ADDENDUM NO1-R1Date: **March 27, 2026**Project No.: **2596**Project: **Alderville Senior's Residence
Renovations**

ALDERVILLE SENIOR'S RESIDENCE RENOVATIONS

Date: March 26, 2026
Project: Alderville Seniors Residence
Renovation
Project No: 25-088
No: ADD-ME01

Date: March 26, 2026
Project: Alderville Seniors Residence
Renovation
Project No: 25-088
No: ADD-ME02

Drawing No:
E201
 Revision:
1

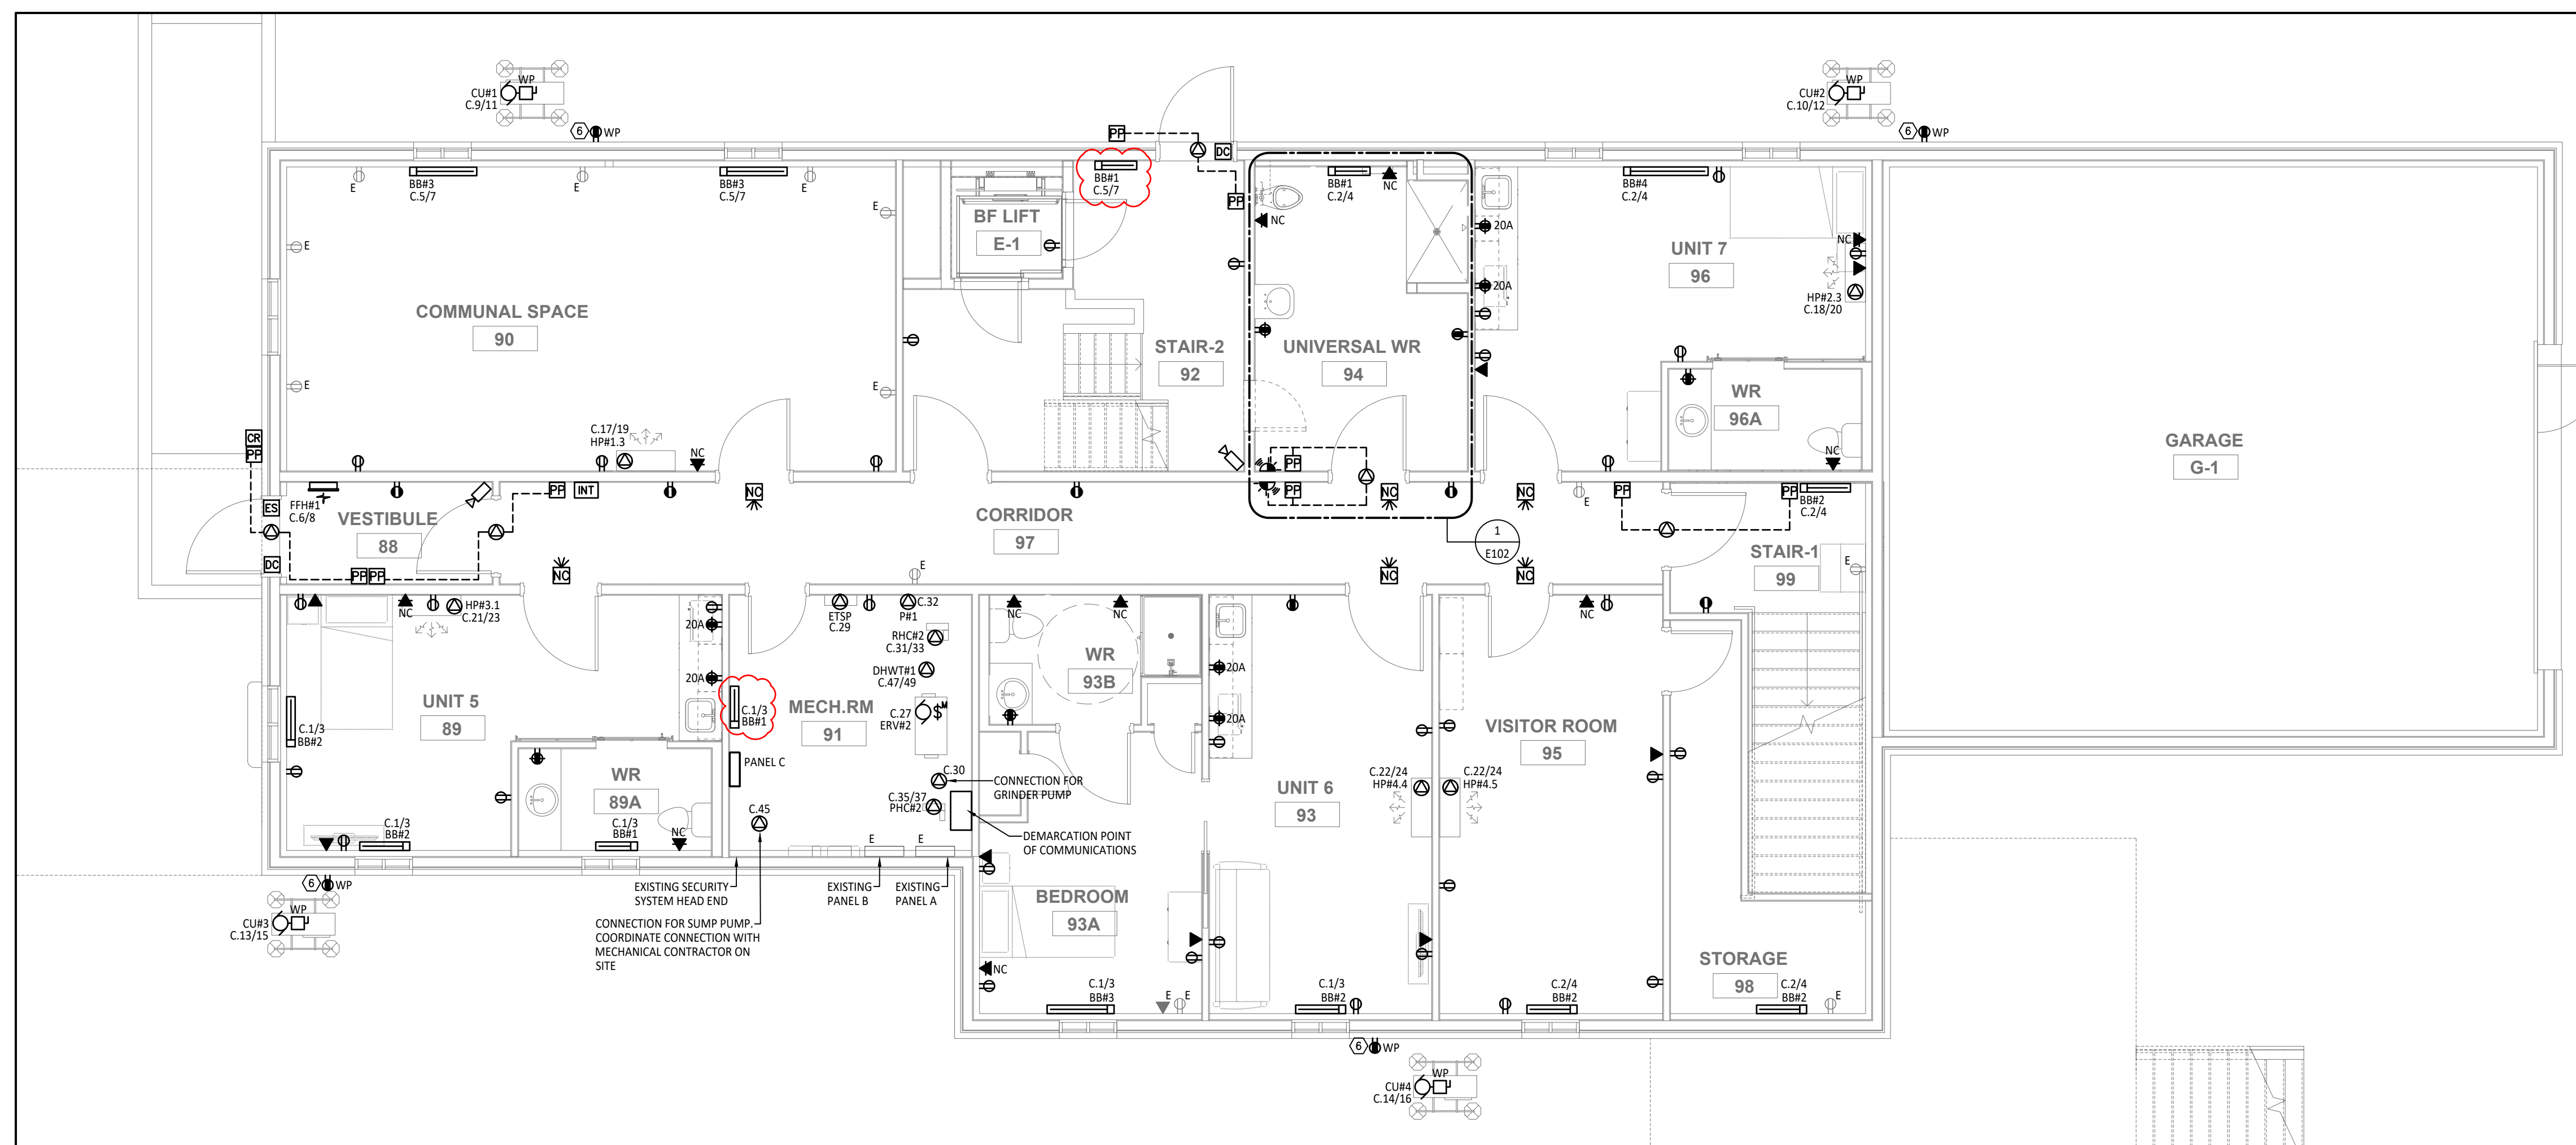
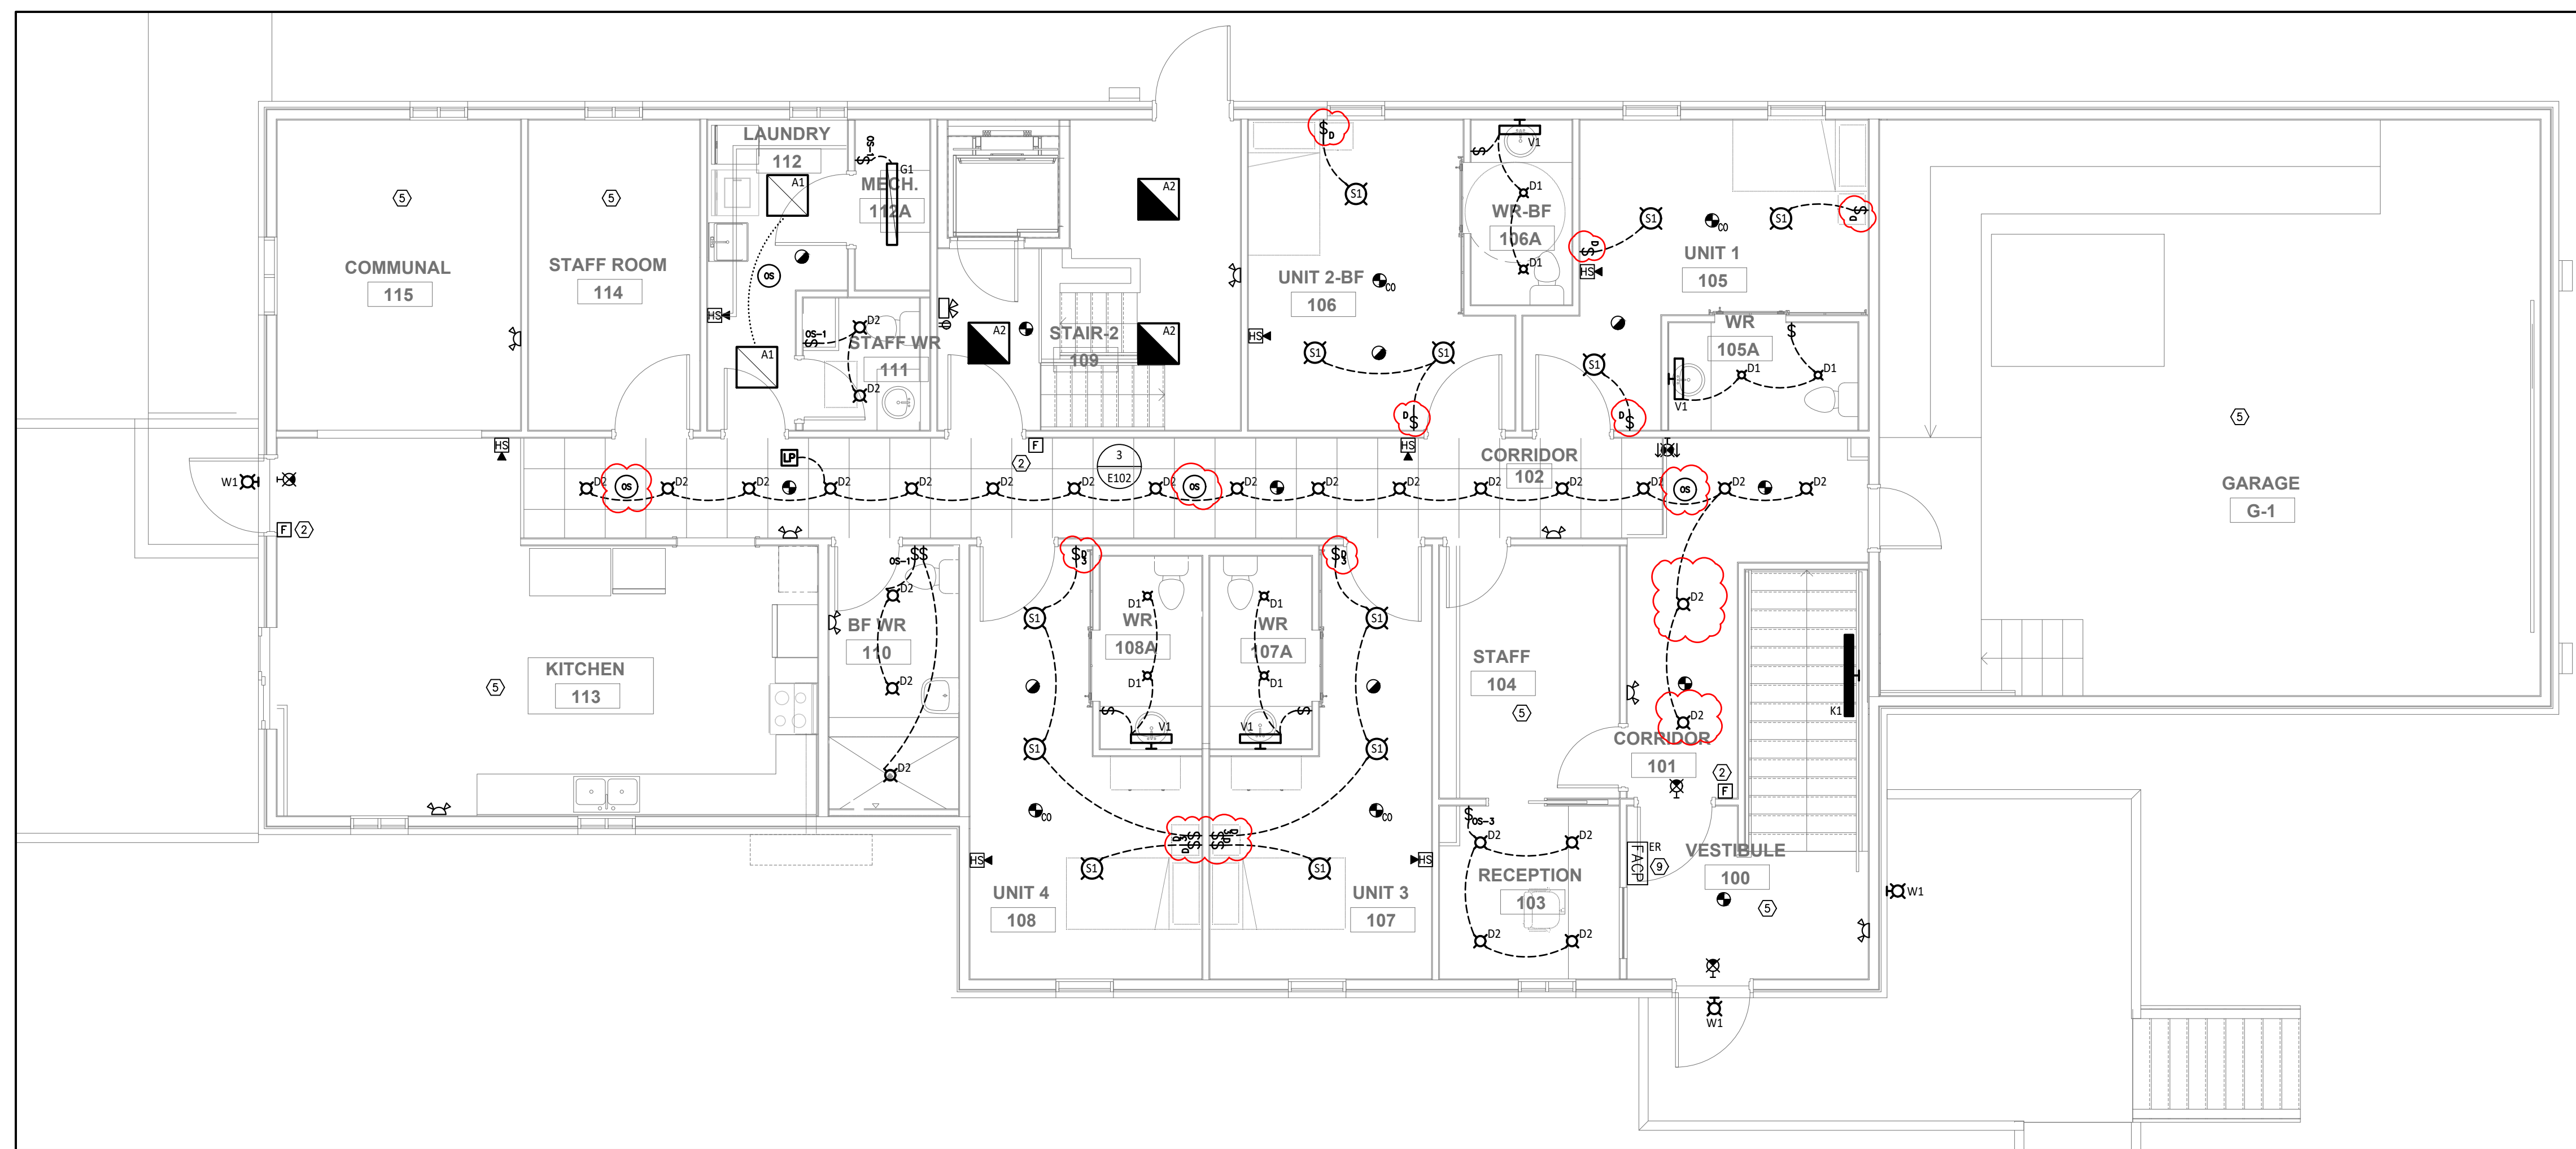
1 REGARDING ELECTRIC BASEBOARD COORDINATION (DRAWING E201 RE-ISSUED)

.1 Refer to attached drawing for revised baseboard locations.
